STATE OF DELAWARE  
EXECUTIVE DEPARTMENT  
OFFICE OF MANAGEMENT AND BUDGET  
Budget Development, Planning and Administration  
State Planning Coordination

RE: PLUS review – 2008-11-03; Northside Shopping Center – Parcel A

Thank you for meeting with State agency planners on November 26, 2008 to discuss the proposed plans for the Northside Shopping Center Parcel A project to be located at Route 301 and Doc Levinson Drive in Middletown.

According to the information received, you are seeking a site plan approval through Middletown for a 60,900 sq. ft. shopping center.

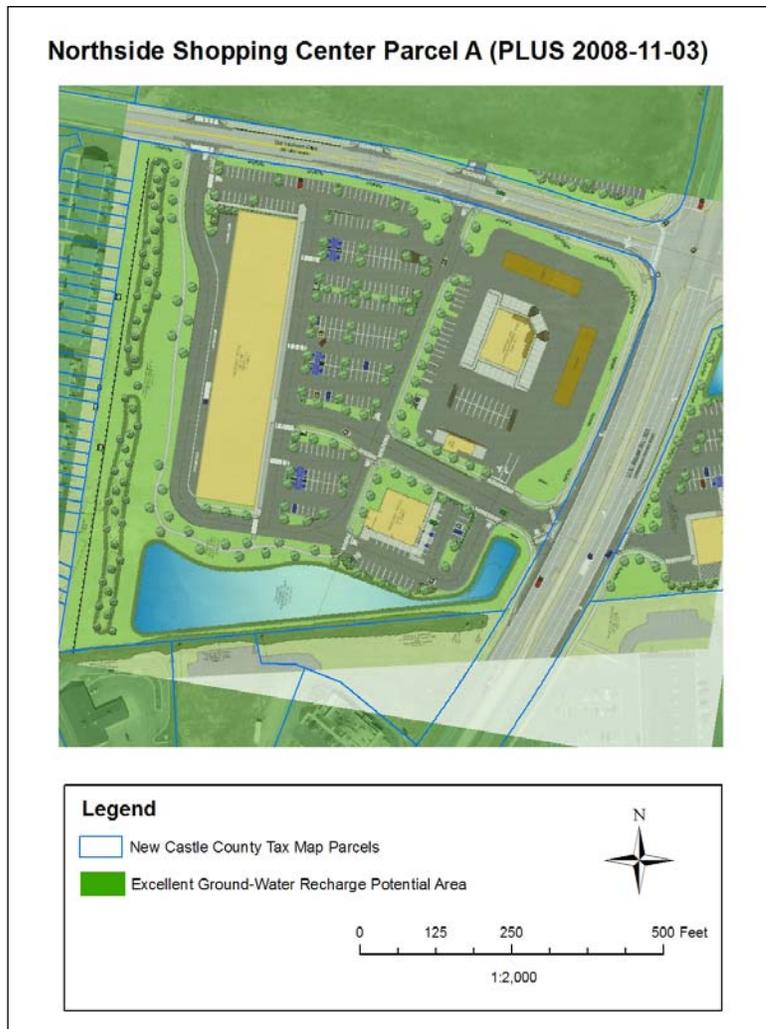
The Water Supply Section, Groundwater Protection Branch (GPB) has determined that the project falls totally within an excellent ground-water recharge area for the Town of Middletown (see following map and attached map).

The GPB recommends that the portion of the new development within the excellent ground-water recharge area not exceed 20% impervious cover. Some allowance for augmenting ground-water recharge should be implemented if the impervious cover exceeds 20% but is less than 50% of that portion of the parcel within this area.

The PLUS Application form indicates that a Gas Station and Car Wash are to be located in the excellent ground-water recharge potential area. Underground storage tanks containing petroleum products have the potential to contaminate the ground water if a release occurs.

The site plans show a storm-water management pond within the area of excellent ground-water recharge potential. This pond is reported to be an infiltration pond with an outflow to the Rt. 301 drainage system. The construction phase of this type of pond requires excavation, hauling, and grading. The heavy equipment used in this phase has the capacity to compact and degrade the structure of the strata that defines the area as an excellent ground water recharge area (Schueler, 2000a). Changes to the structural soil properties may cause significant reduction in recharge capacity resulting in release of water to the Rt. 301 drainage system further reducing recharge quantity. Installing storm-water management ponds in excellent ground-water recharge areas has the potential to contaminate the ground water beneath it and infiltrate into the aquifer (Schueler, 2000b).

- Reduce impervious cover to less than 50%
- Perform an environmental assessment report showing that *water quality* as well as *water quantity* of post development recharge is equal to or greater than pre-development recharge (Kaufmann, 2005).
- Quantify amount of recharge lost due to impervious cover and provide for onsite infiltration of water at least equal to or greater than pre-development recharge (Kaufmann, 2005).
- Pretreatment of parking area runoff to remove chemical and nutrient loads
